Forum Boulevard Improvements Project

Chapel Hill to Woodrail

Project Sponsor: City of Columbia – Public Works Department

COMMENT FORM | INTERESTED PARTIES MEETING – NOVEMBER 30, 2023

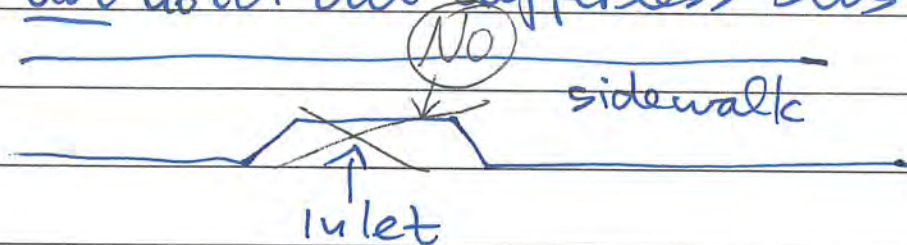
Provide green buffer between SW & roadway wherever possible.

- Do not note out bufferless SWs for inlets

- Where RAB goes from 2 to 1 lane, make sure to paint forward arrow on right (through) lane.
- Provide on/off ramps for bikes ahead & behind RAB to SW
- Do not put right angles / tall curbs at SWs
